**EASTSOUND SEWER AND WATER DISTRICT
WASTEWATER TREATMENT PLANT UPGRADE – PHASE 2**

**ADDENDUM NO. 1 (6 pages total)
Issue Date: February 11, 2025**

Exhibit: Airport Vertical Ceiling Surface

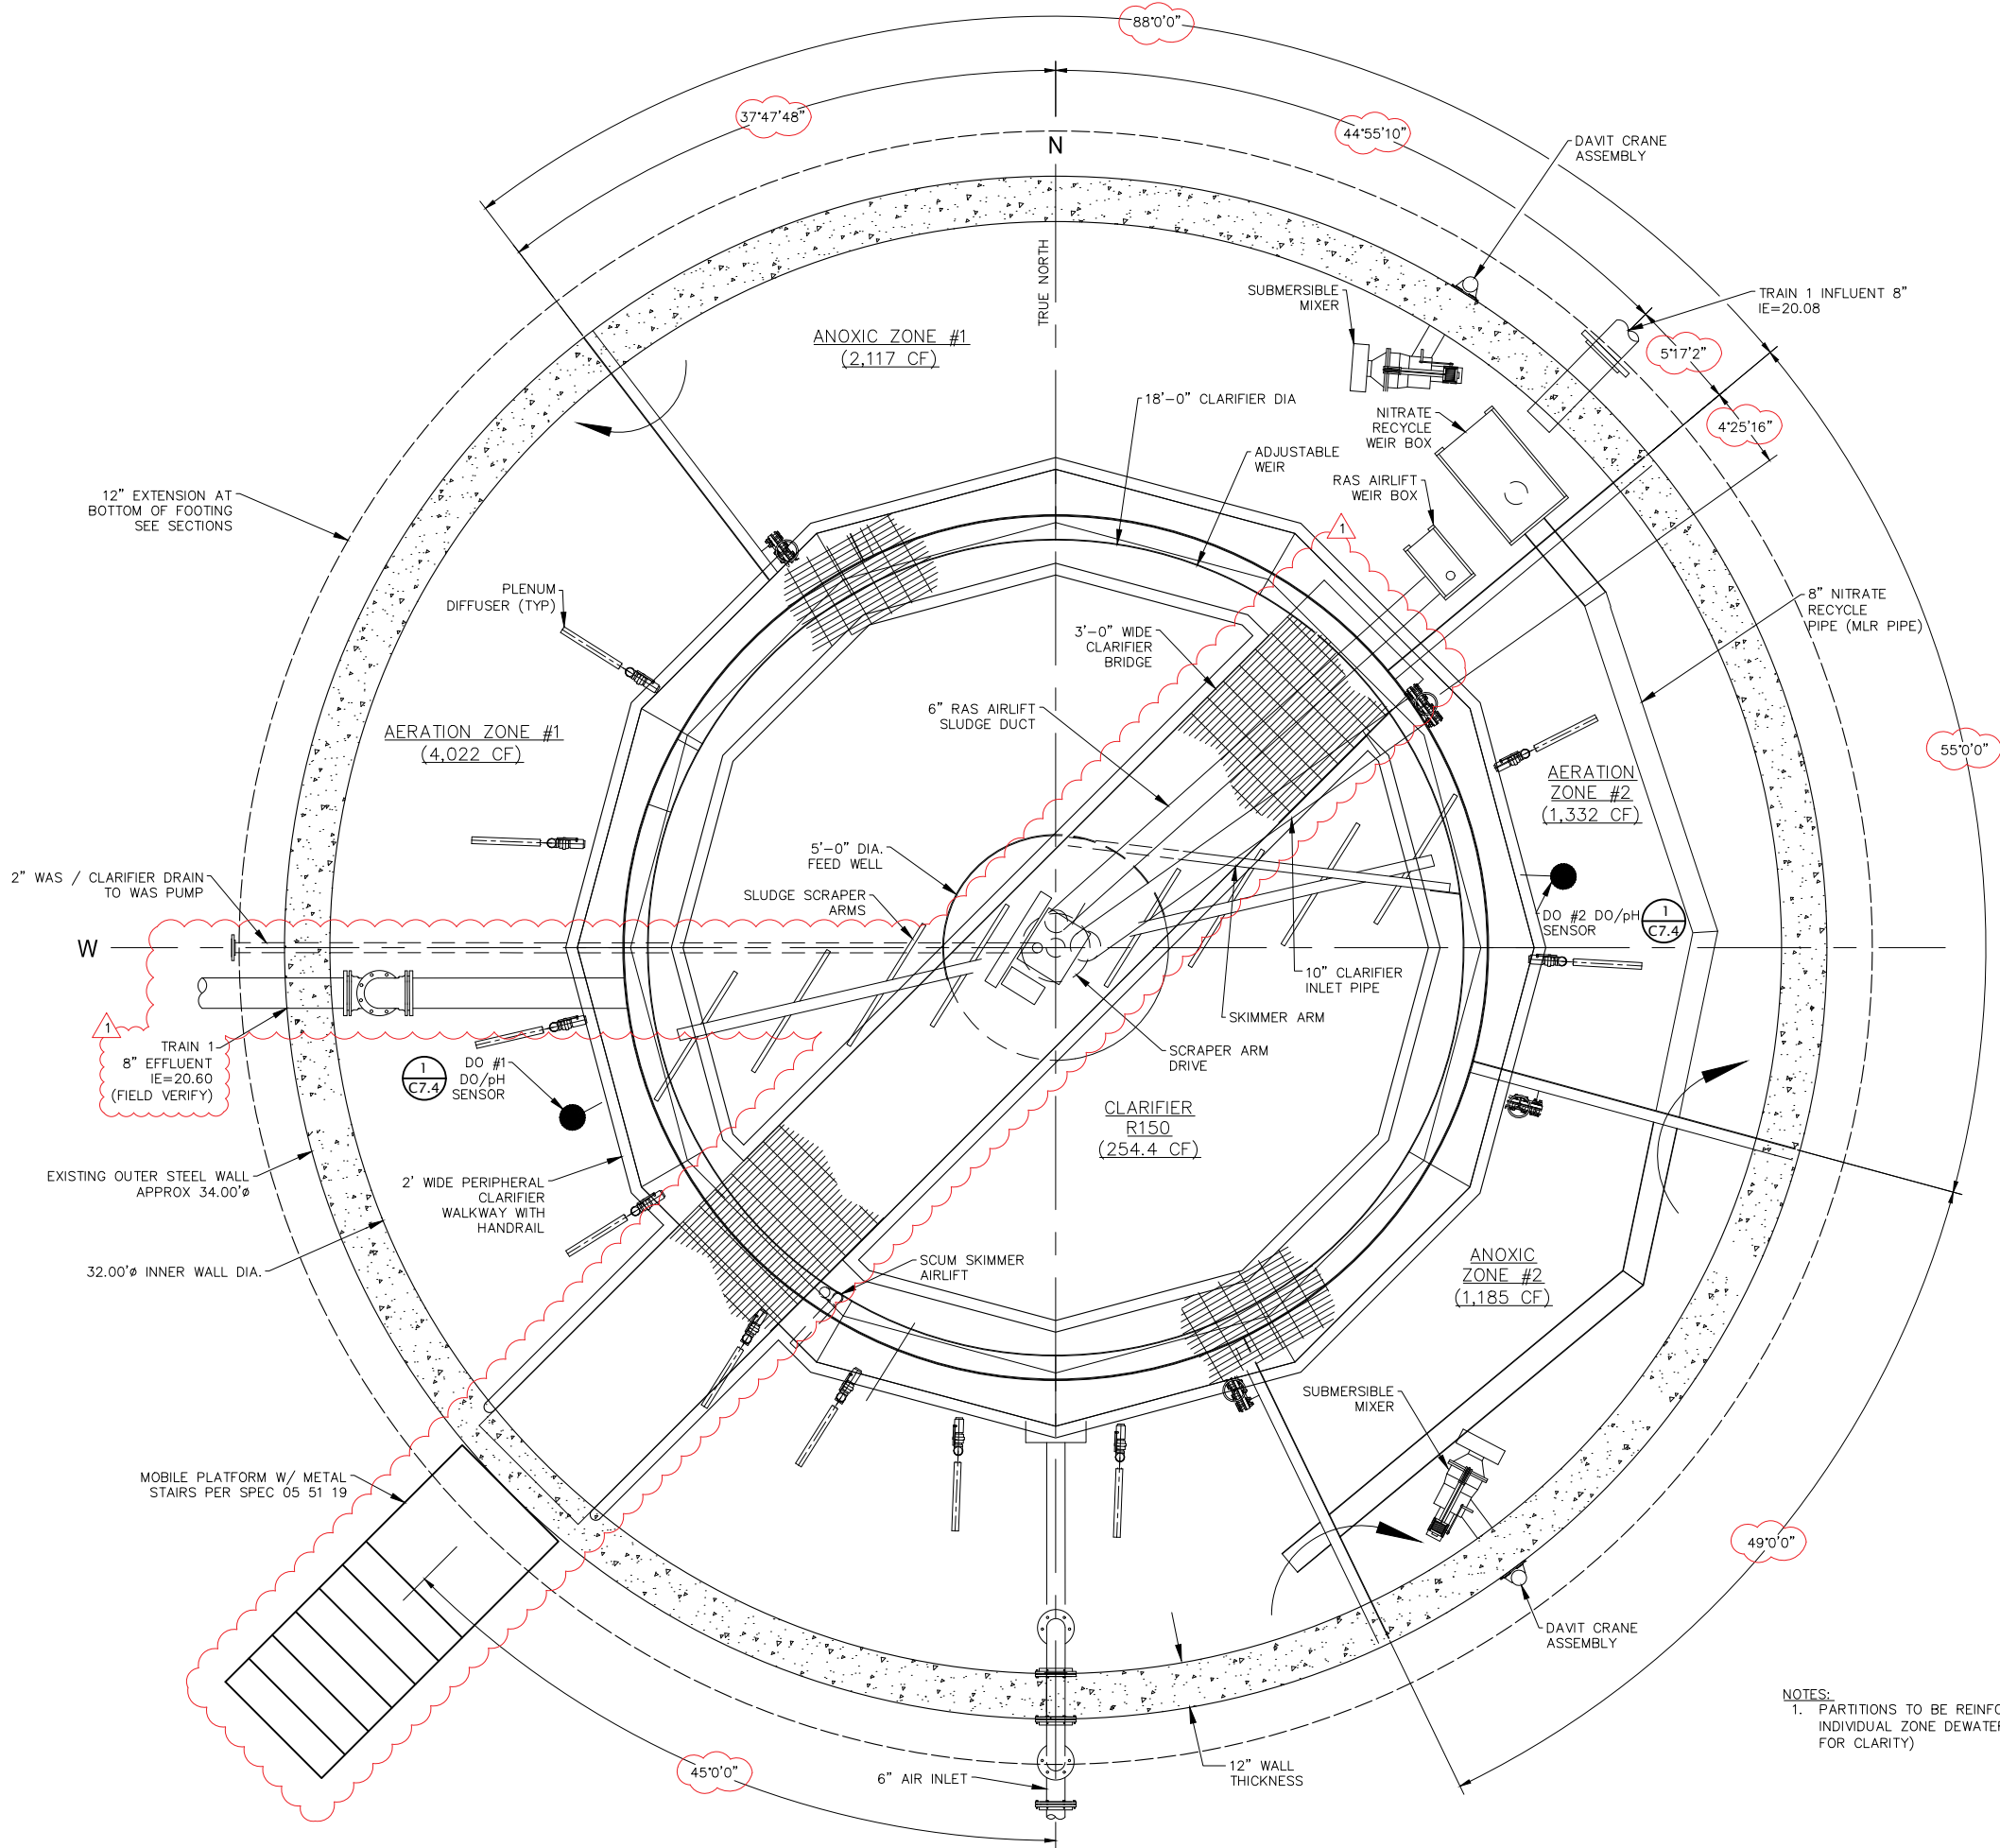
6. Airport Vertical Ceiling Surface:

Due to the proximity of the WWTP site to the Port of Orcas Airport, buildings and other obstructions must not clear the Transitional Surface that surrounds the airport per FAA regulations. The Transitional Surface extends over the site at a 7:1 angle. Vertical clearance

from finish grade to the Transitional Surface ranges from 34 ft clearance (approx.) on the west side of the WWTP site to 54 ft clearance (approx.) on the east side of the WWTP site. Please see the attached exhibit titled: Airport Vertical Ceiling Surface.

SHEET	DATE	SCALE	JOB NUMBER
C3.1	2-11-2025	AS SHOWN	2023-123
PAGE	29	OF	91

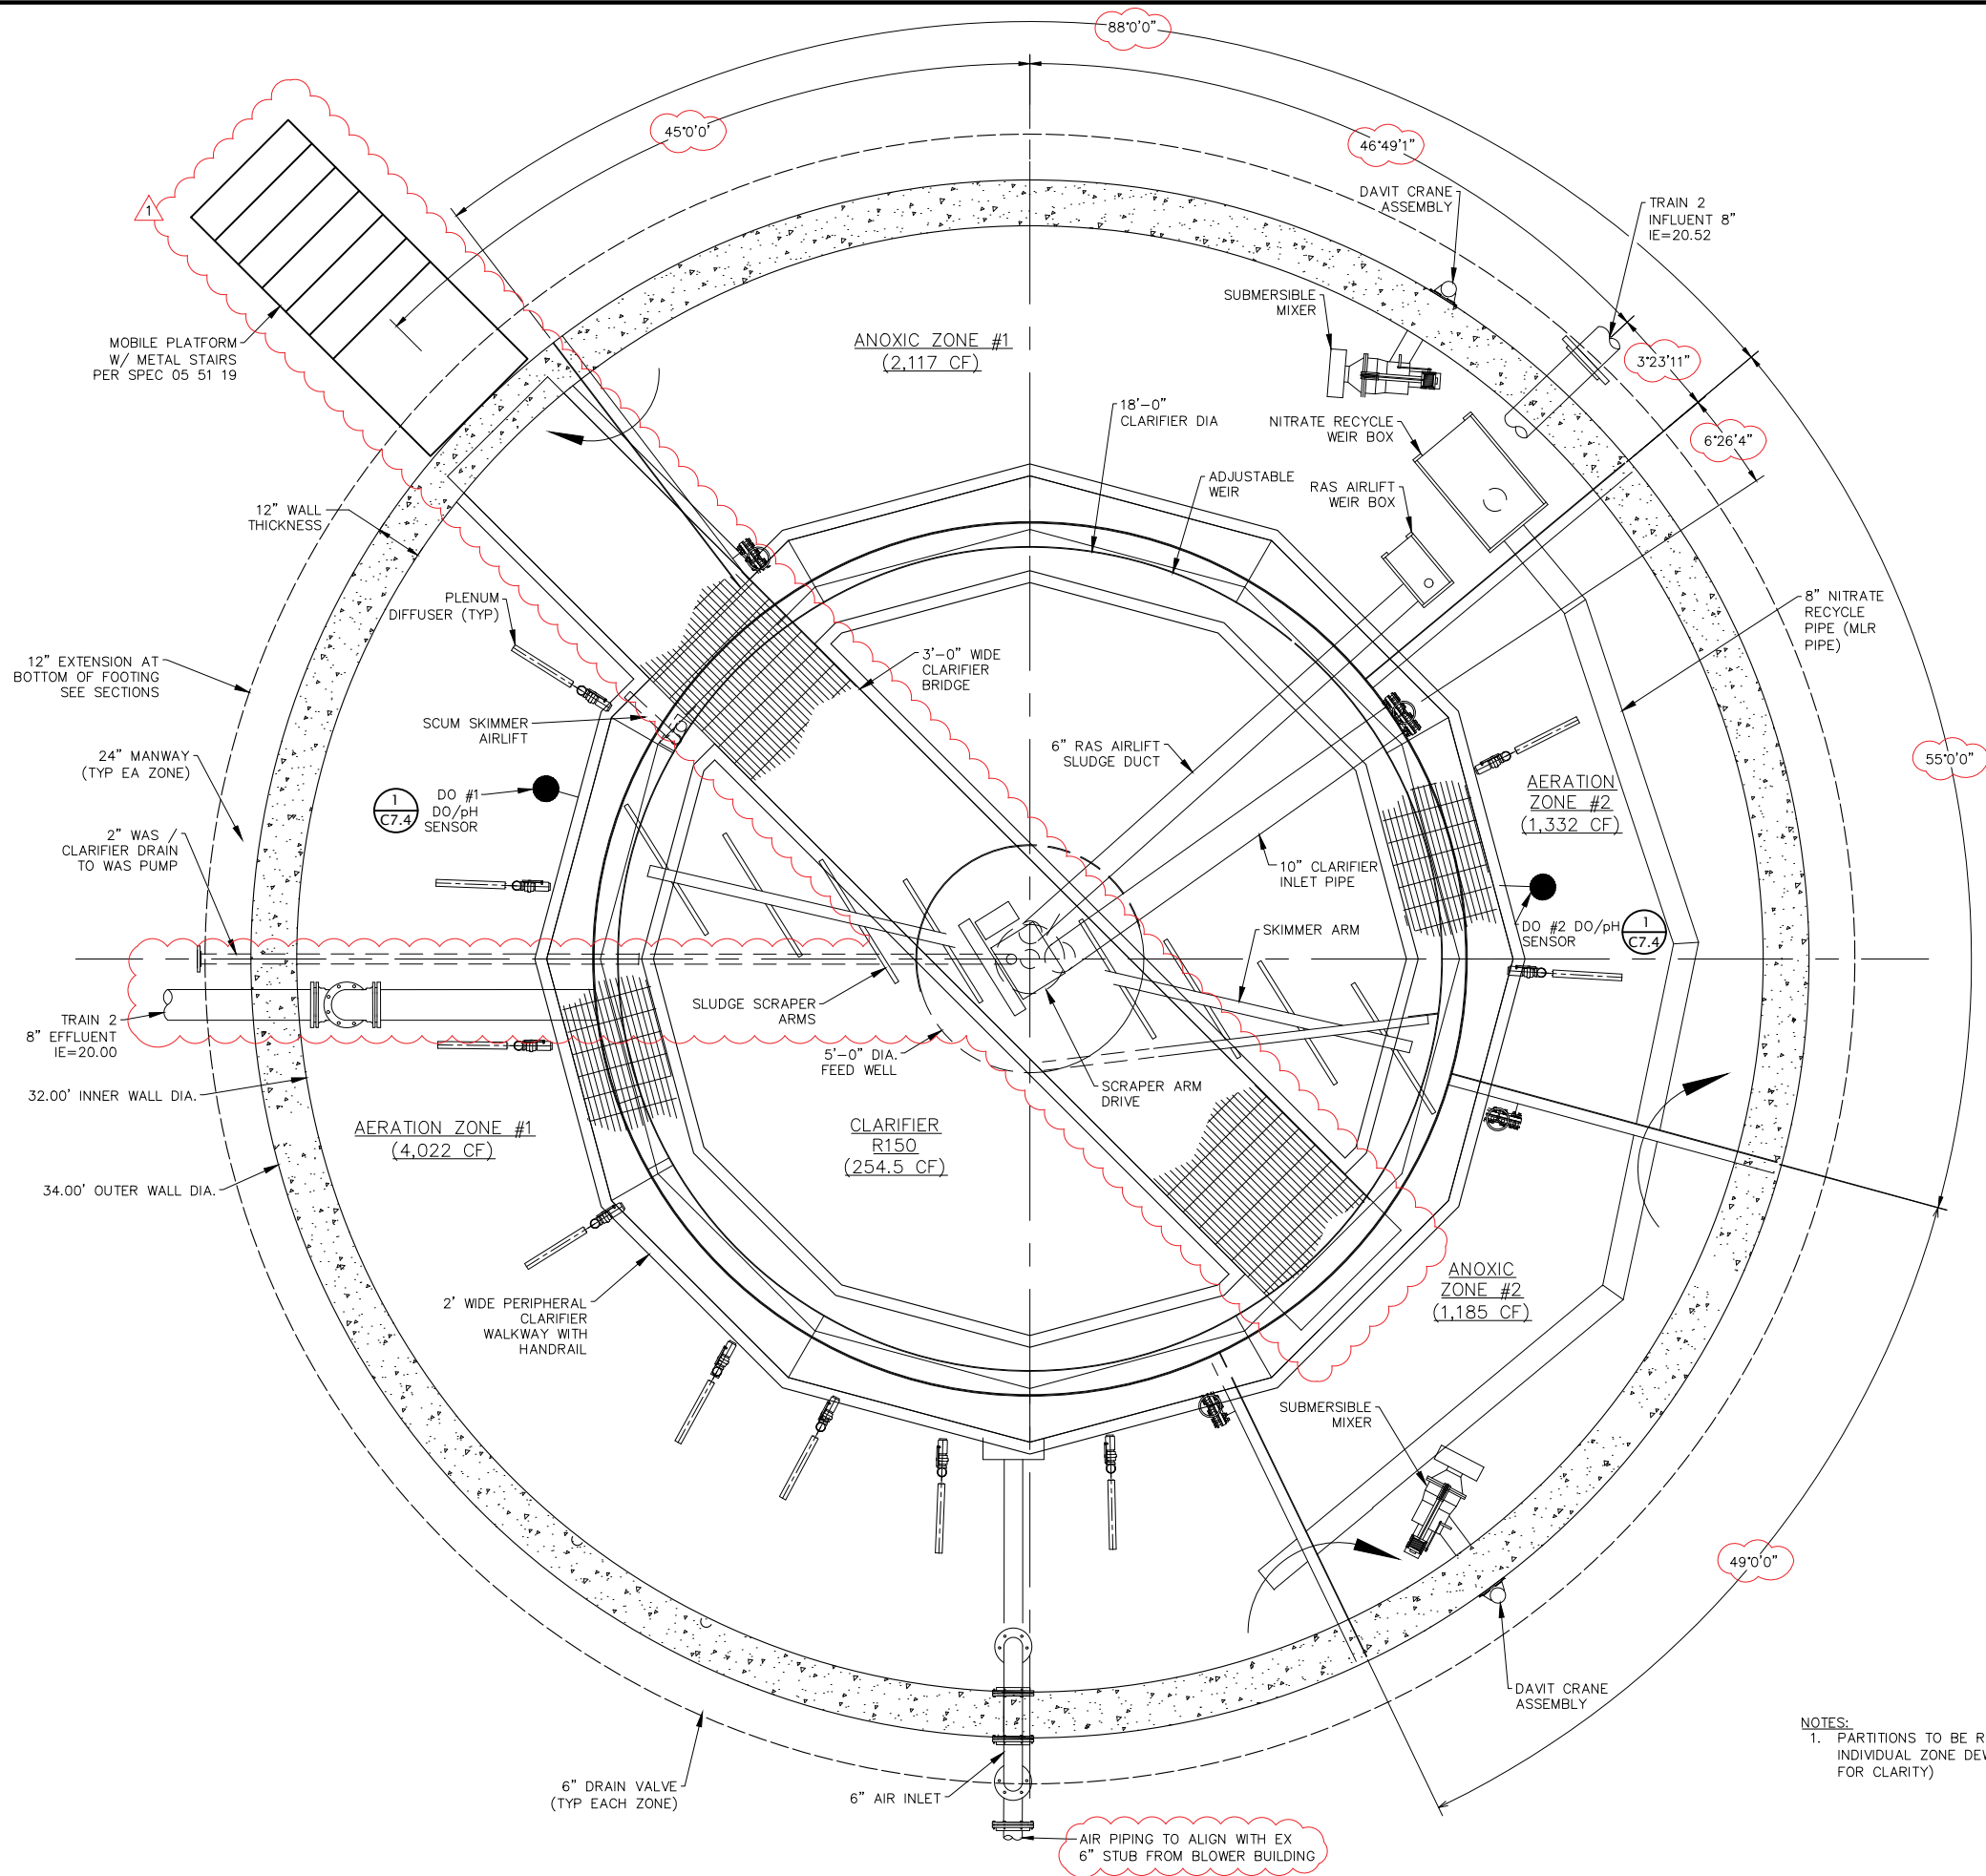
Sheet C3.1:

- The clarifier's access walkway for Train 1 has been rotated. The Train 1 walkway is now oriented 45 degrees SW to NE. The reason for this change is to allow sufficient clearance between Train 1 and Train 2's the mobile stairways as specified in Section 05 51 19.
- The IE of the Train 1's 8" effluent pipe has been adjusted to IE = 20.60 (not 20.00), to be field verified.
- The WAS pipe has been corrected to be in-line with the East-West centerline of the train.
- Two 90 degree elbows were added to the effluent pipe properly show vertical transition.
- Additional dimensions have been added to locate inlet/outlets and partitions within the treatment train.
